**RECONSTRUCTION OF ENCINA AVENUE
FROM MIDDLEFIELD ROAD TO END**

**COUNTY PROJECT NO. RW703
PROJECT FILE NO. E5044000**

ADDENDUM NO. 1

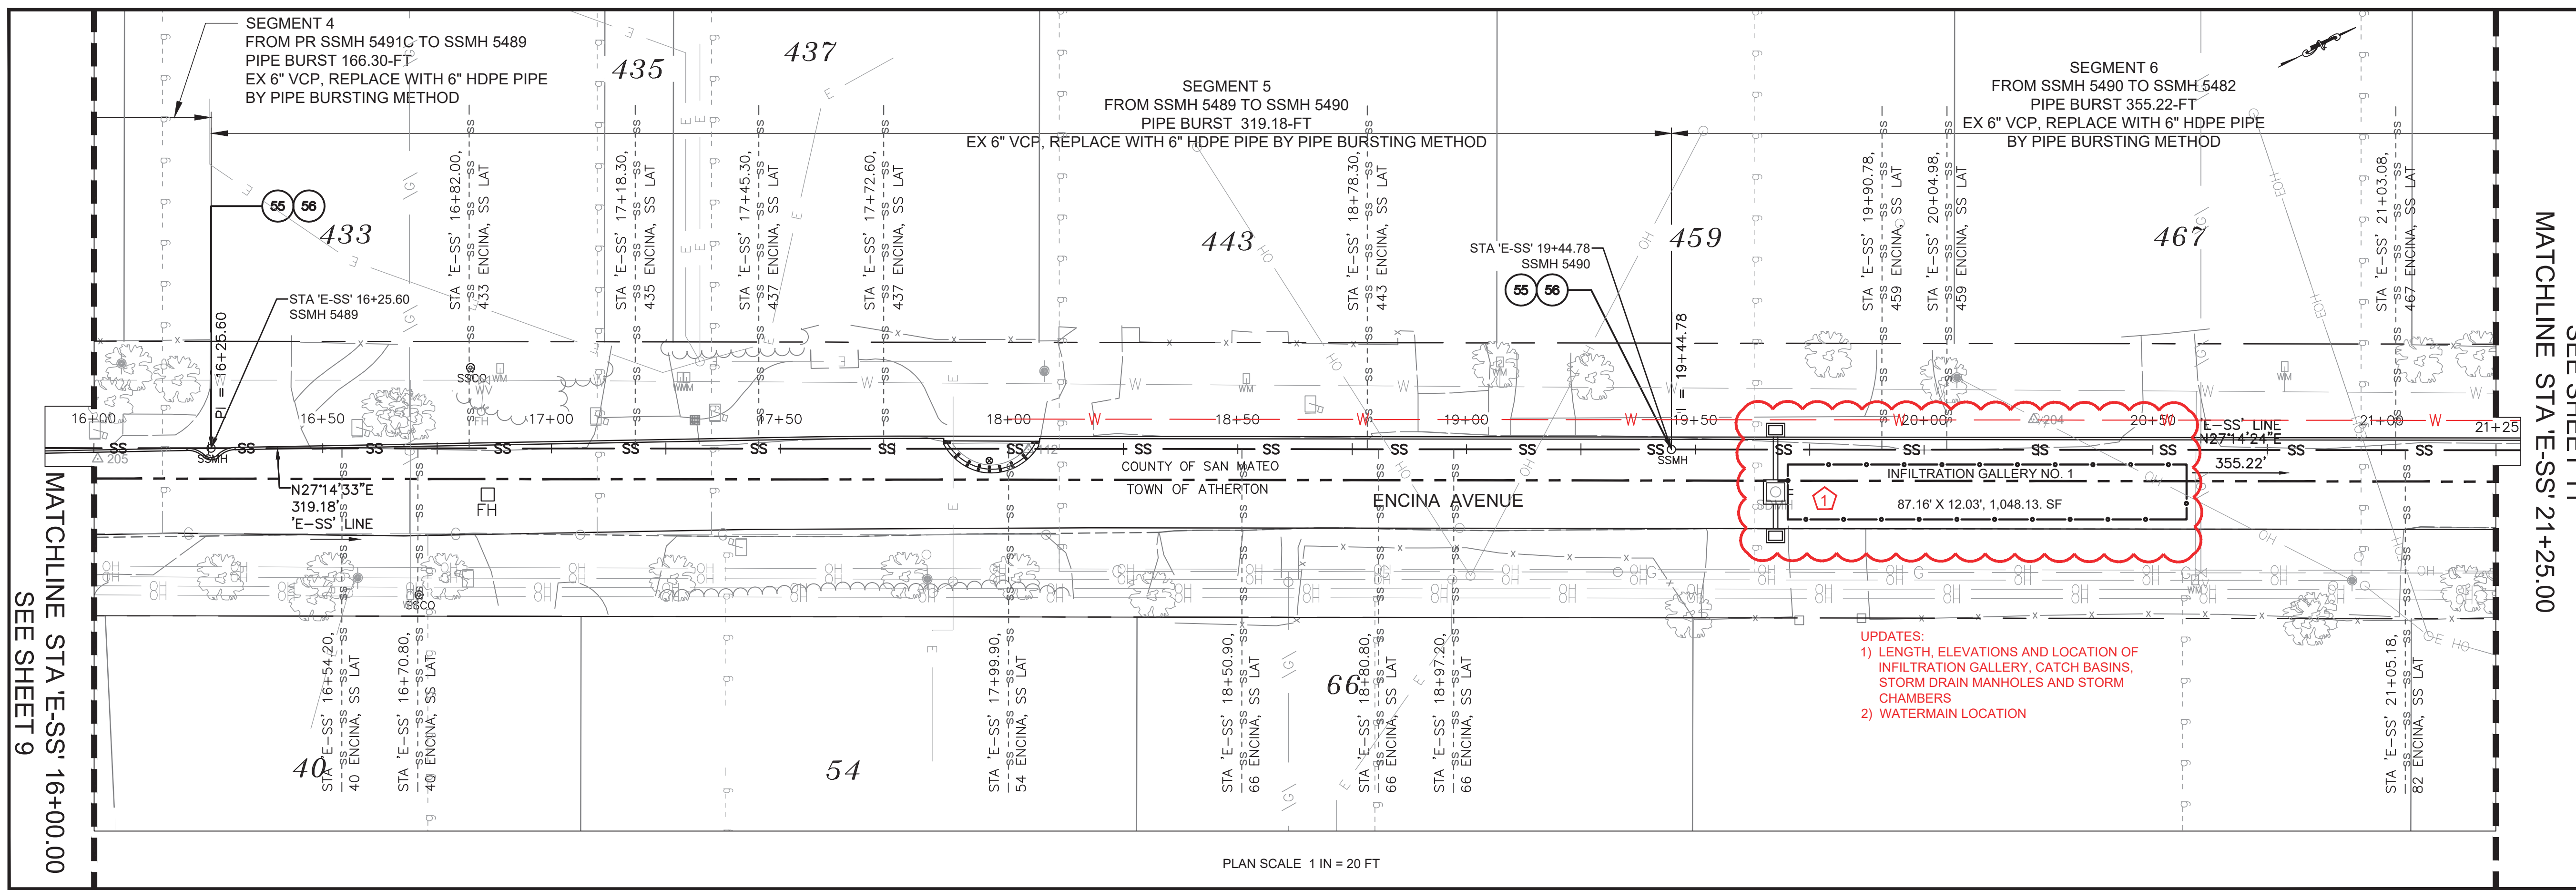
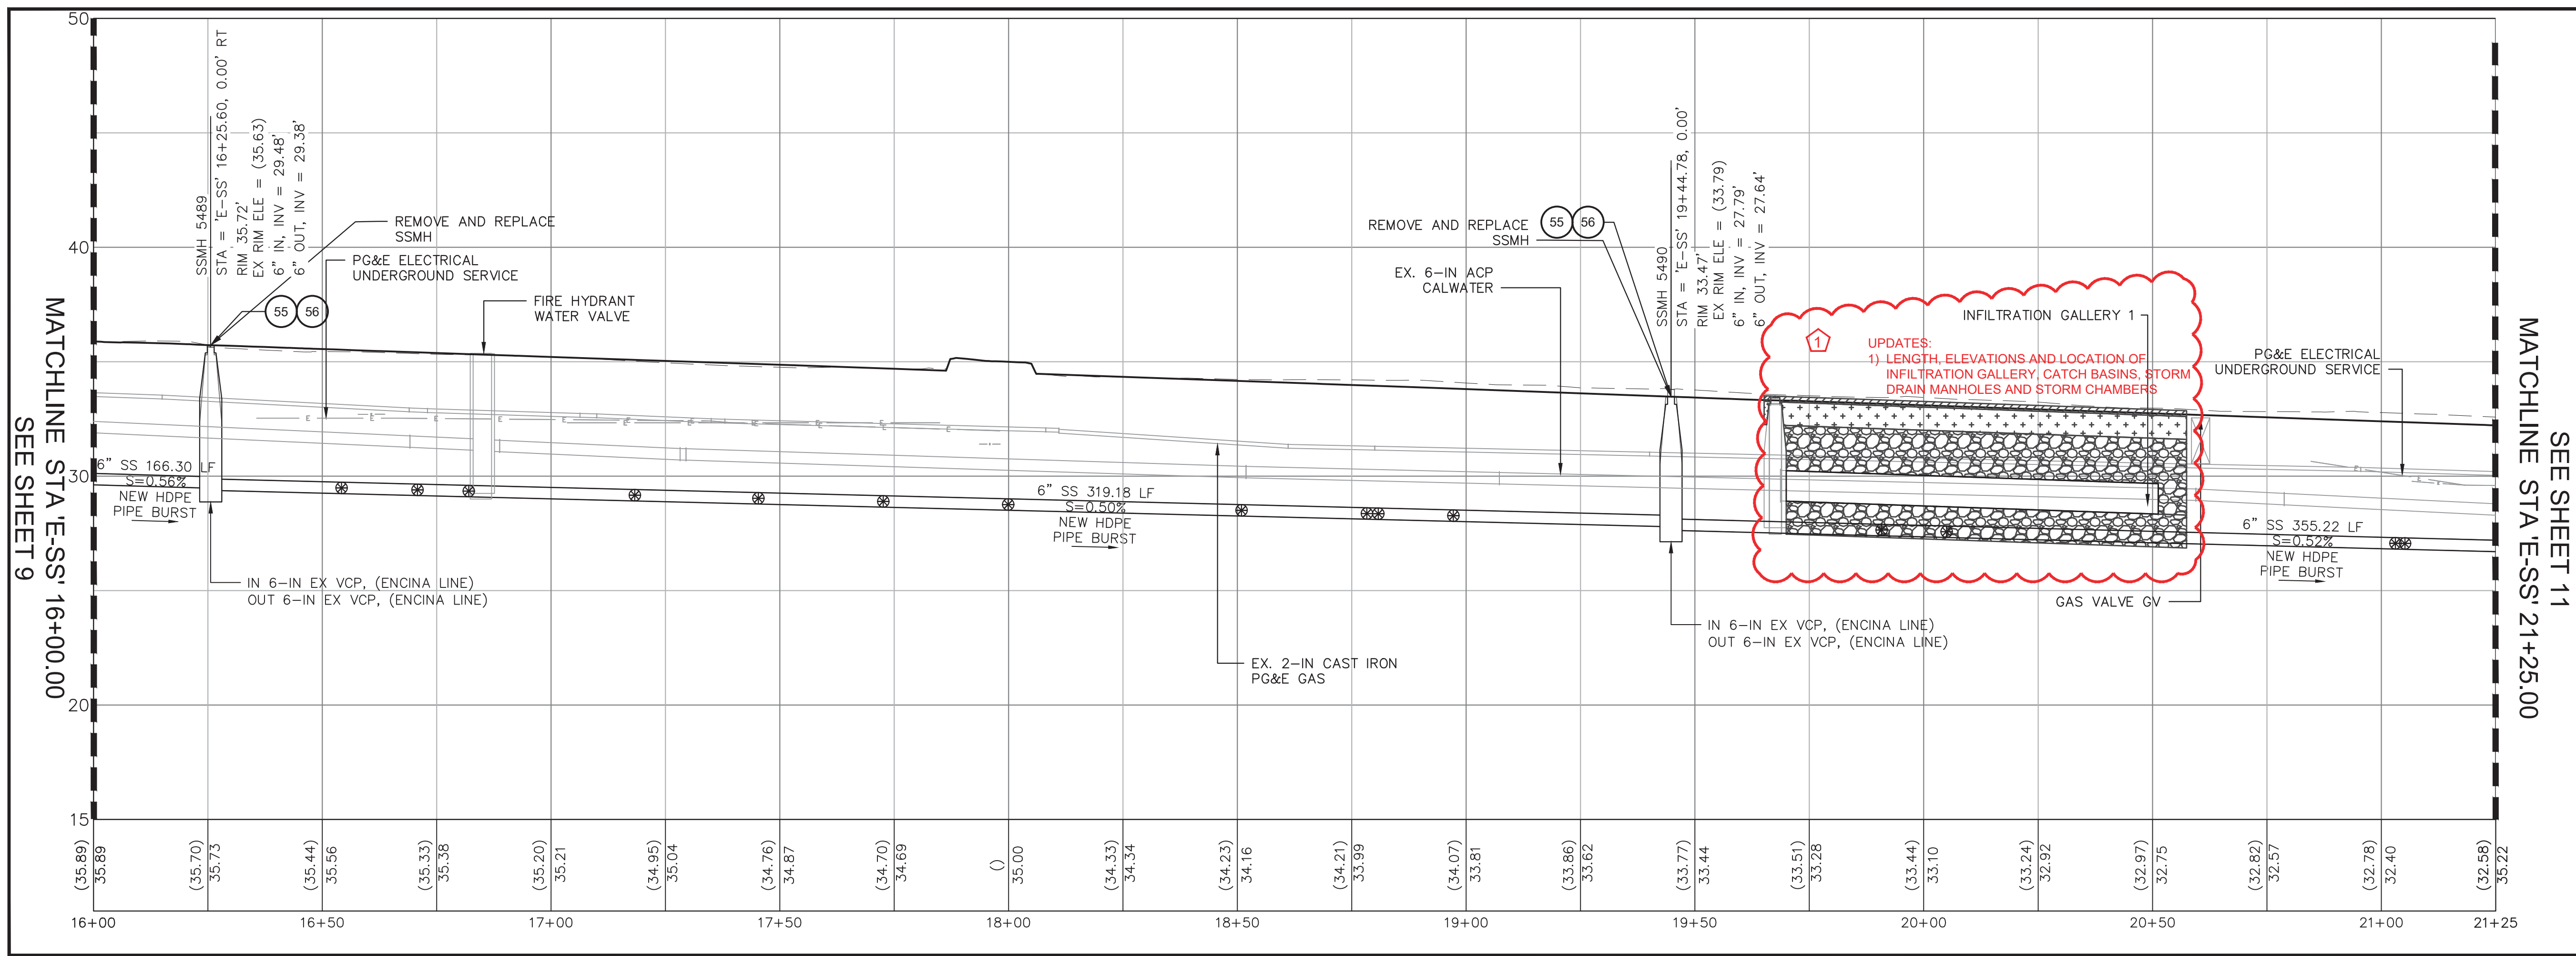
UPDATES:
 1) LENGTH, ELEVATIONS AND LOCATION OF INFILTRATION GALLERY, CATCH BASINS, STORM DRAIN MANHOLES AND STORM CHAMBERS
 2) WATERMAIN LOCATION

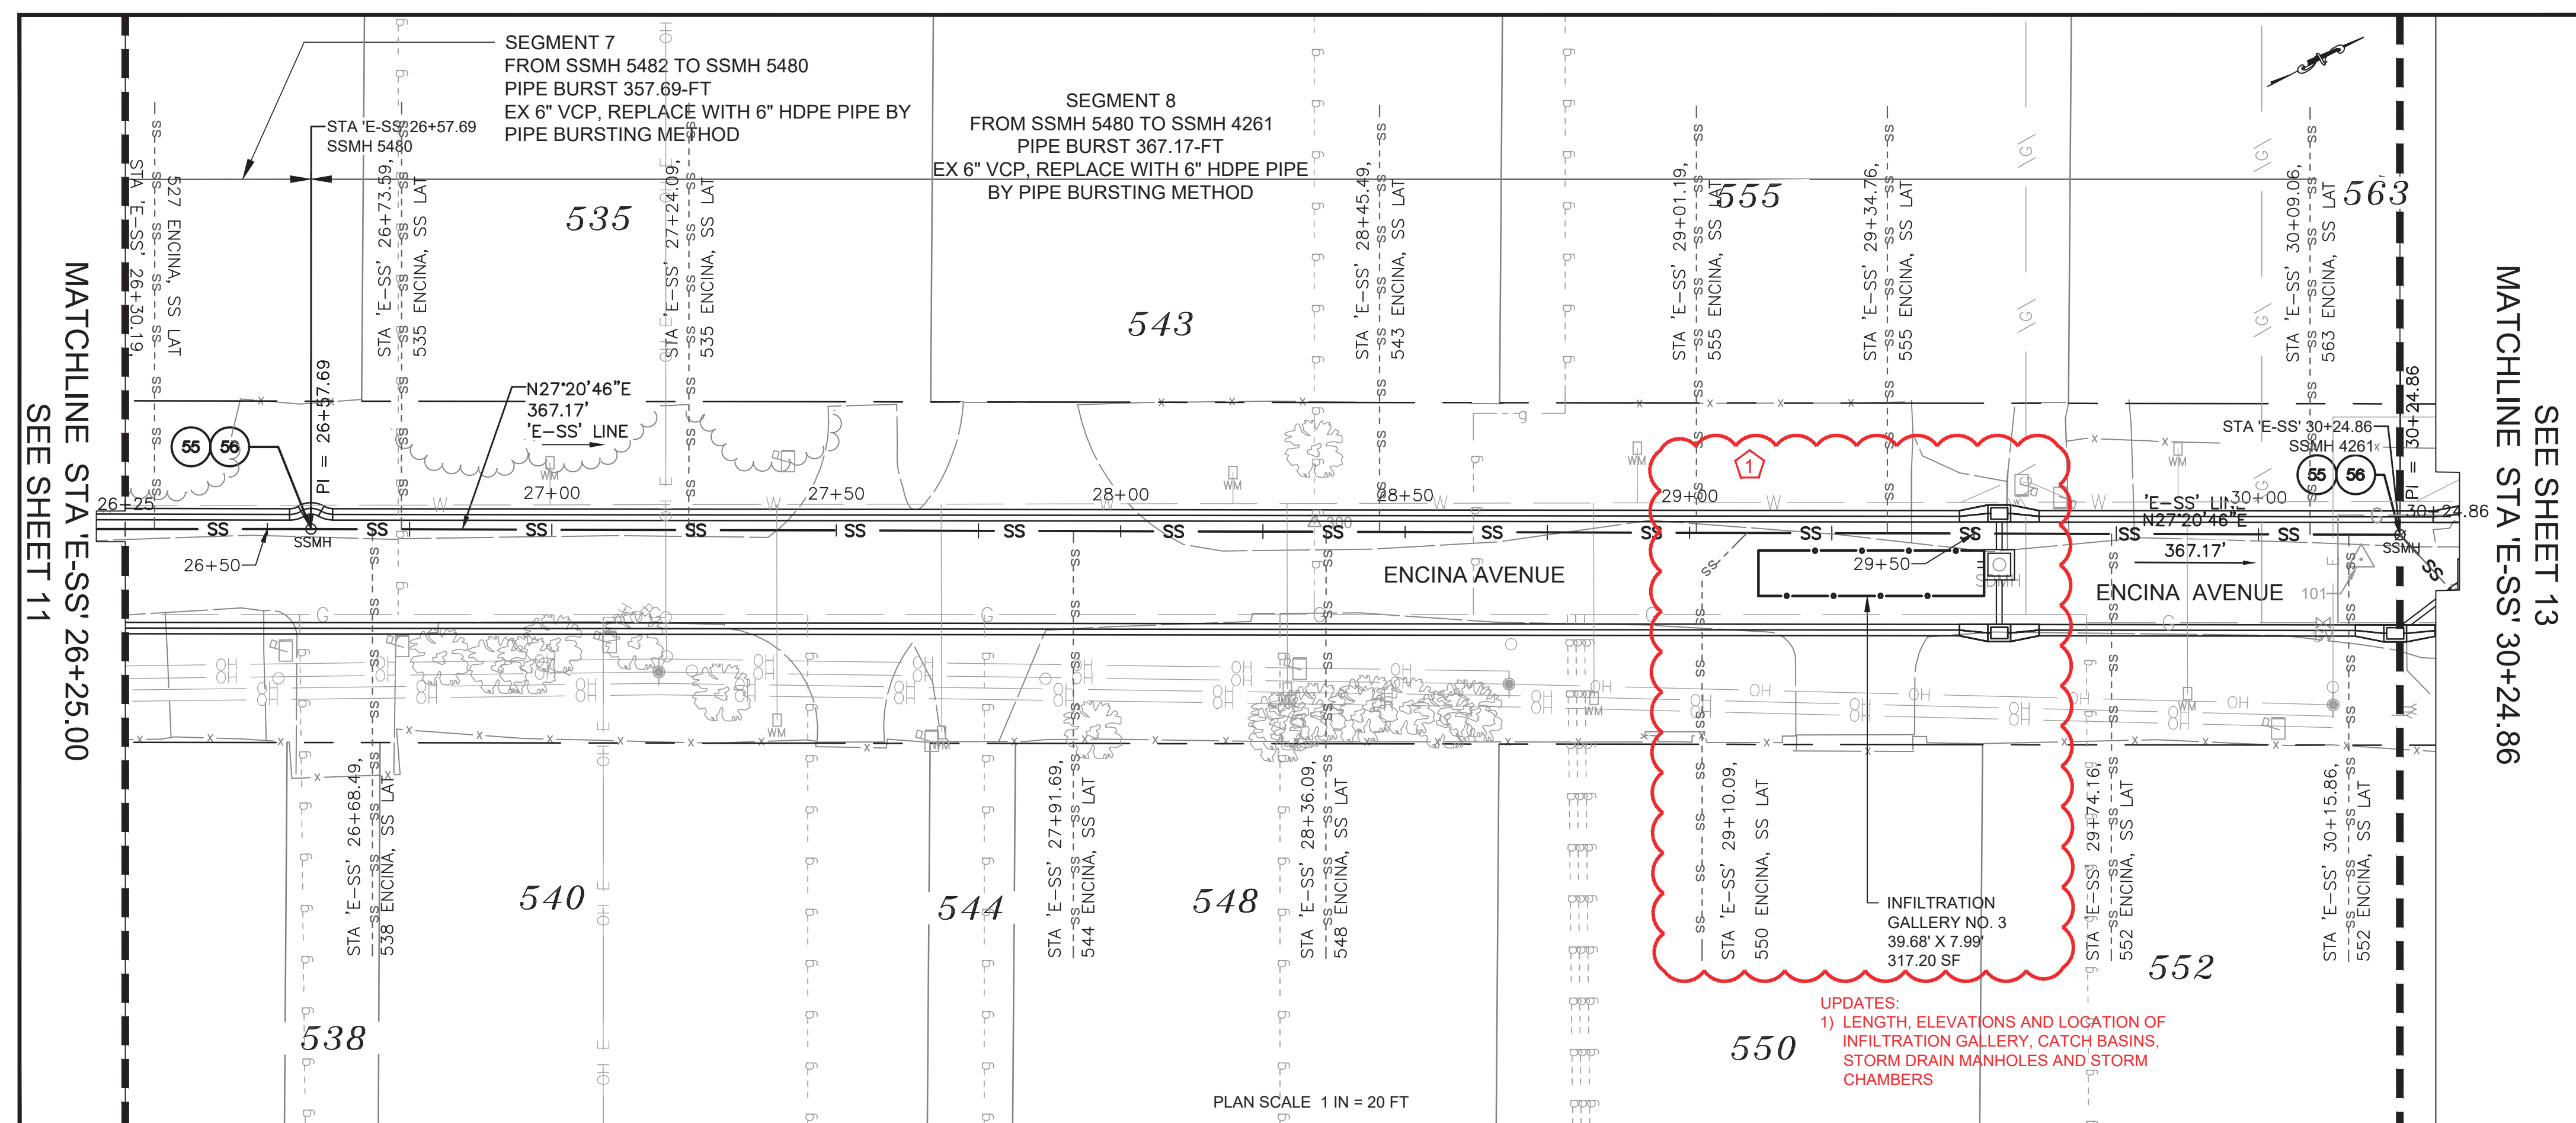
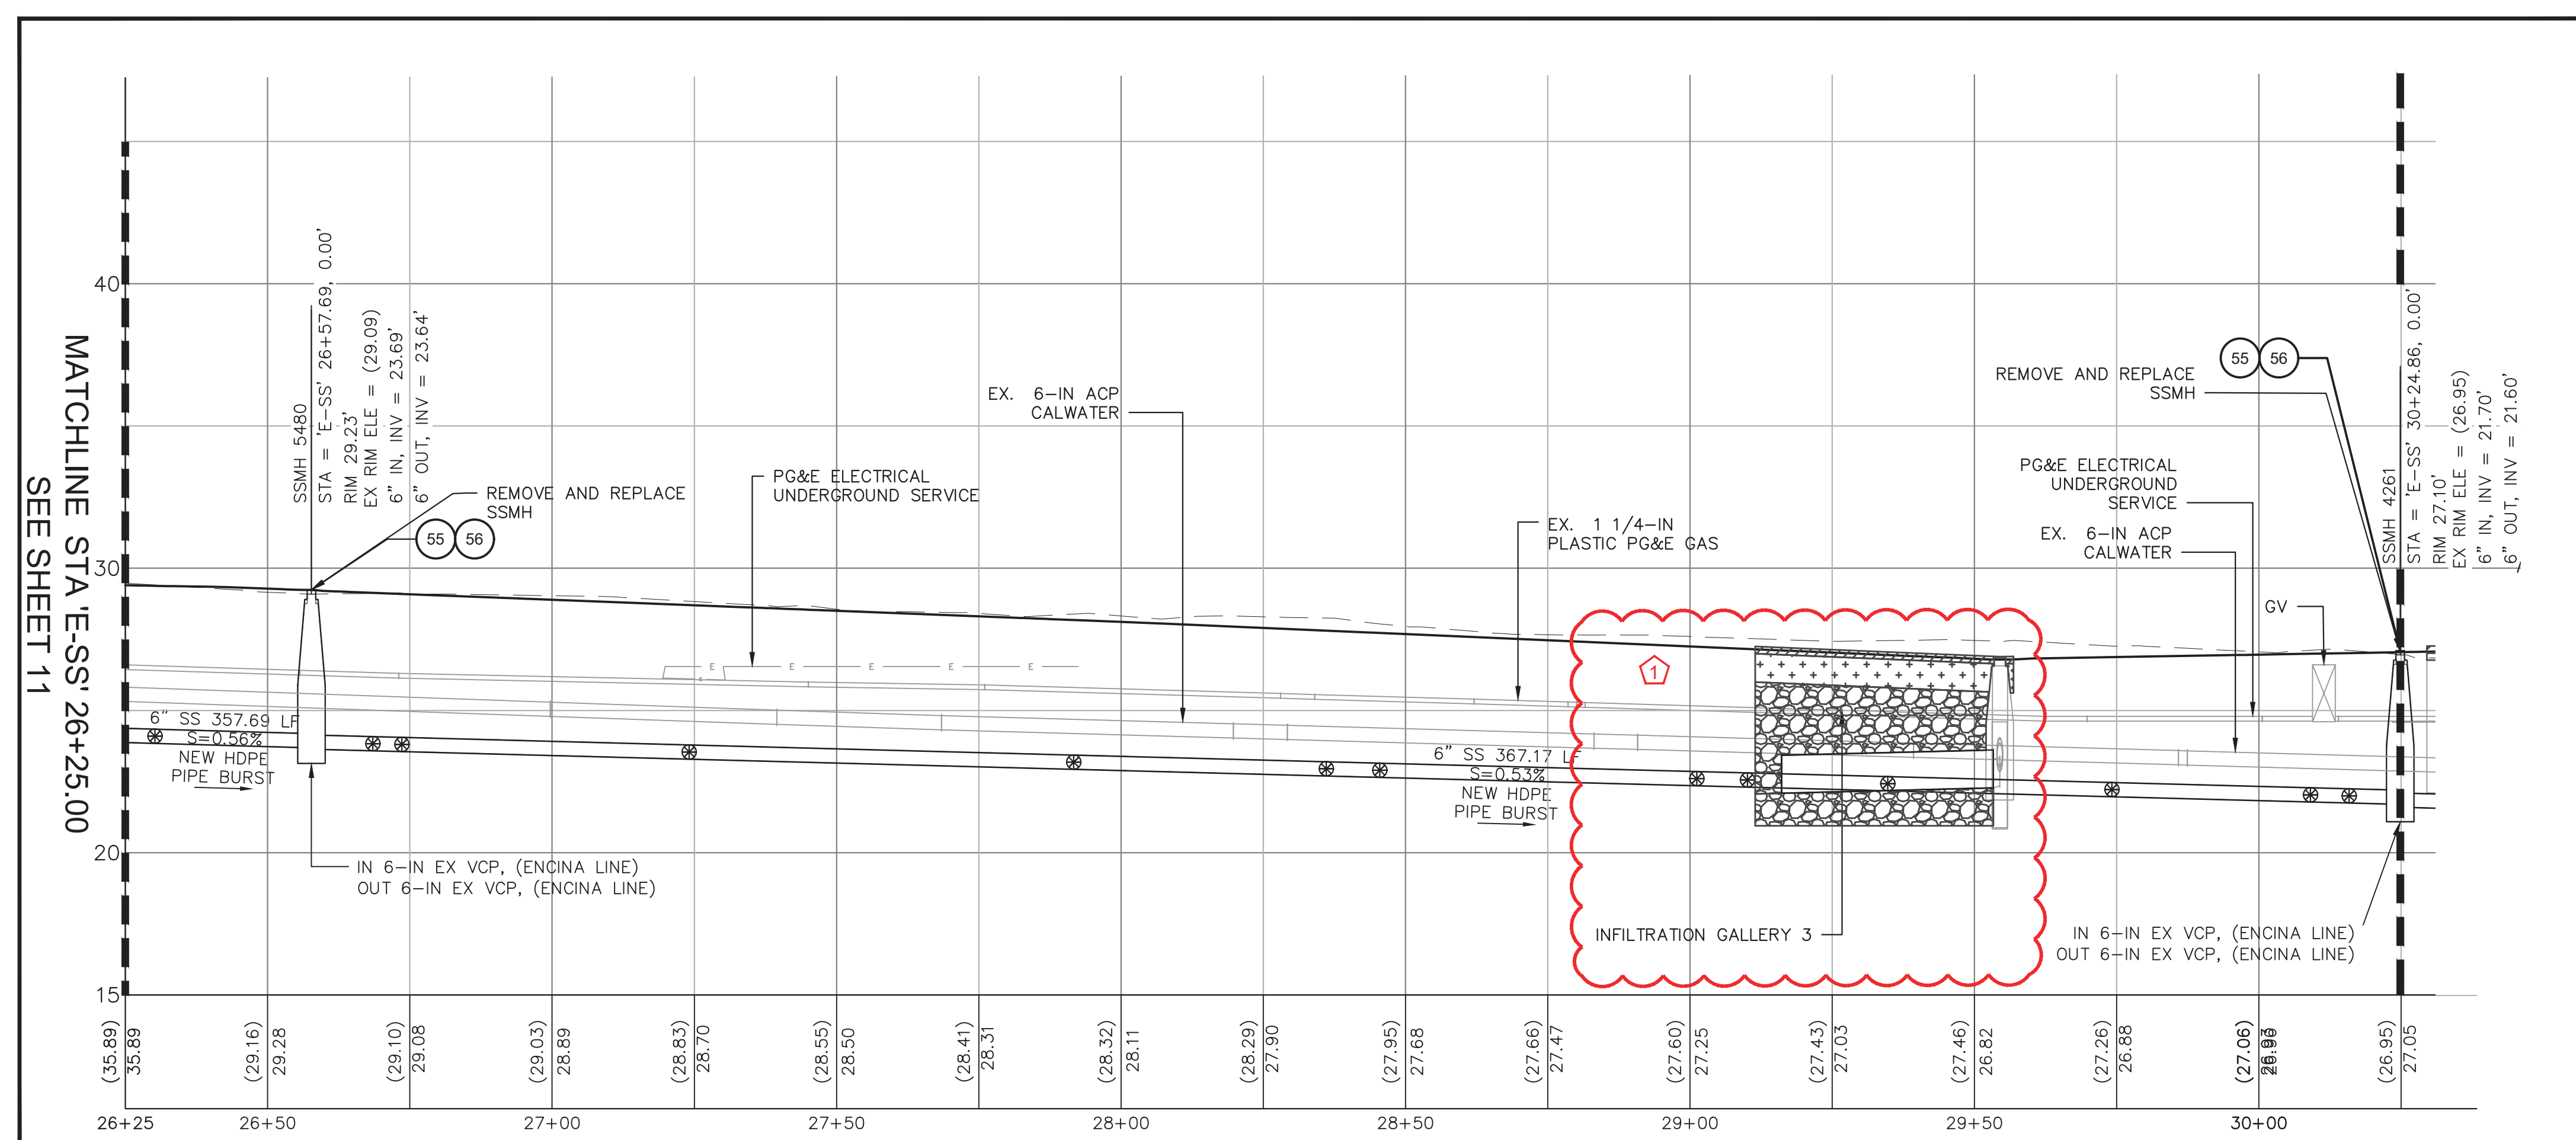
UPDATES:
 1) LENGTH, ELEVATIONS AND LOCATION OF
 INFILTRATION GALLERY, CATCH BASINS,
 STORM DRAIN MANHOLES AND STORM
 CHAMBERS
